APPLICATION NO.	FILING DATE	FIRST NAMED INVENTOR	ATTORNEY DOCKET NO.	CONFIRMATION NO.
09/849,006	05/04/2001	George Nelson Bliss	17306/101	1810
26646 75	90 10/03/2003		EXAMINER	
KENYON & KENYON			CHIN, PAUL T	
ONE BROADW NEW YORK, 1			ART UNIT PAPER NUMBER	
, -			3652	· · · · · · · · · · · · · · · · · · ·
			DATE MAILED: 10/03/2003	3

Application No.	A	<i>_</i> _
r ·	Application No.	Applicant(s)	
Office Action Commence	09/849,006	BLISS ET AL.	
Office Action Summary	Examiner	Art Unit	
	PAUL T. CHIN	3652	
The MAILING DATE of this communication app Period for Reply	ears on the cover sheet with th	e correspondence addre)SS
A SHORTENED STATUTORY PERIOD FOR REPLY THE MAILING DATE OF THIS COMMUNICATION. - Extensions of time may be available under the provisions of 37 CFR 1.13 after SIX (6) MONTHS from the mailing date of this communication. - If the period for reply specified above is less than thirty (30) days, a reply - If NO period for reply is specified above, the maximum statutory period w - Failure to reply within the set or extended period for reply will, by statute, - Any reply received by the Office later than three months after the mailing earned patent term adjustment. See 37 CF

EXHIBIT A

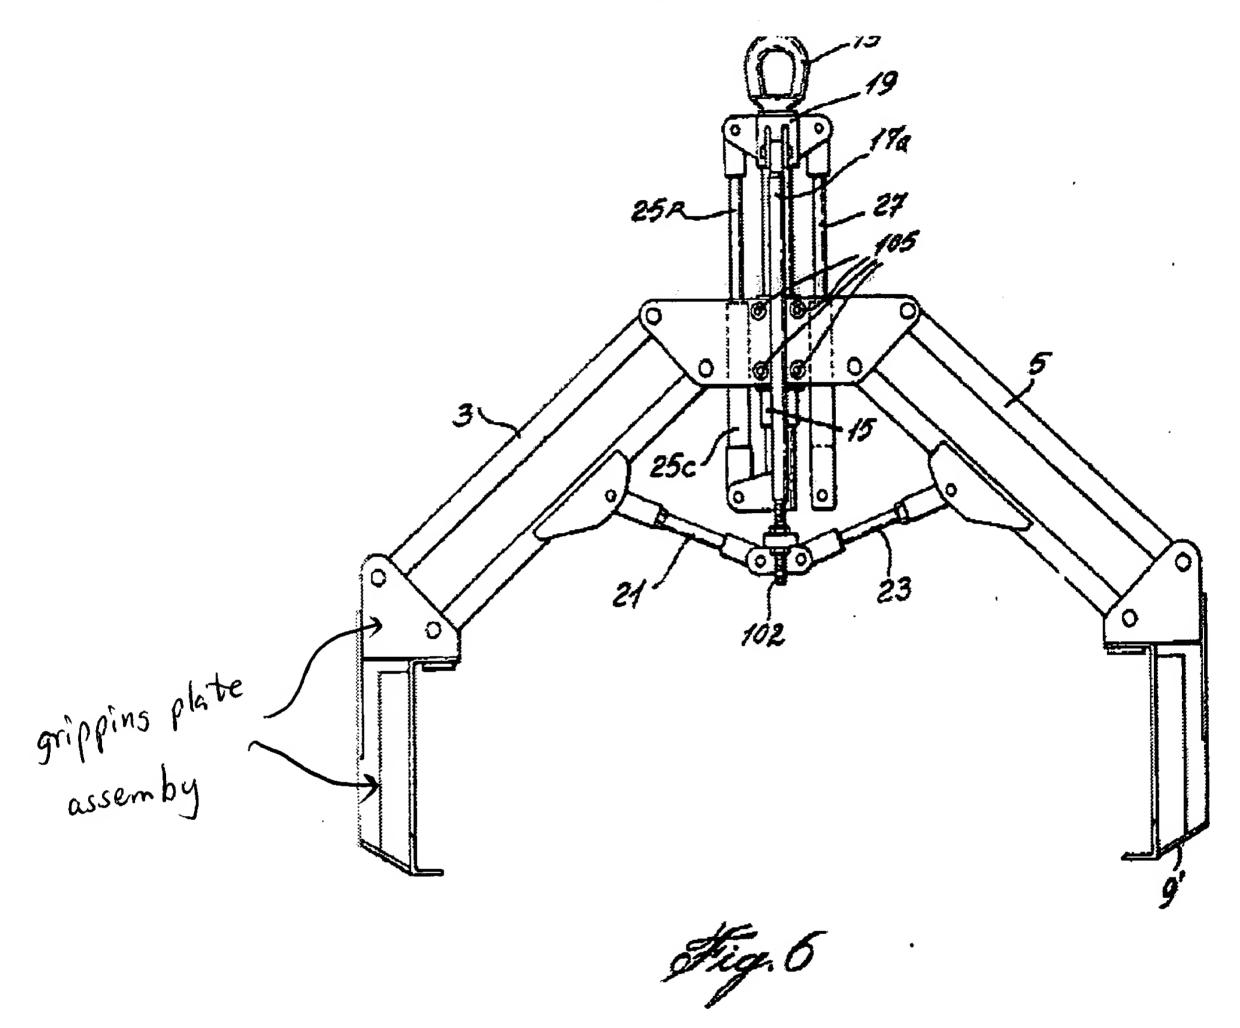
Re claims 1 and 13, Faughnan (4,303,269) discloses an apparatus for gripping and releasing at least one tem, comprising a pickup head (31,33) (see Figs. 1-3); at least one gripping plate assembly (see **Exhibit A**, see next page); a restraining device having at least a first link (3a or 5a) and a second link (3b or 5b) wherein the first link and the second link connected to the pickup head and the gripping plate assembly; the restraining device configured so that the gripping plate assembly is movable between an open position and a closed position in an at least one degree of freedom; and an actuation device (25,27) to move the gripping plate assembly between the open position and the closed position. It is pointed out that an end of gripping plate being displaced inwardly by the restraining device when the gripping plate moved form the open position to the closed position (see Fig. 1, an open position, and Fig. 2, a closed position).
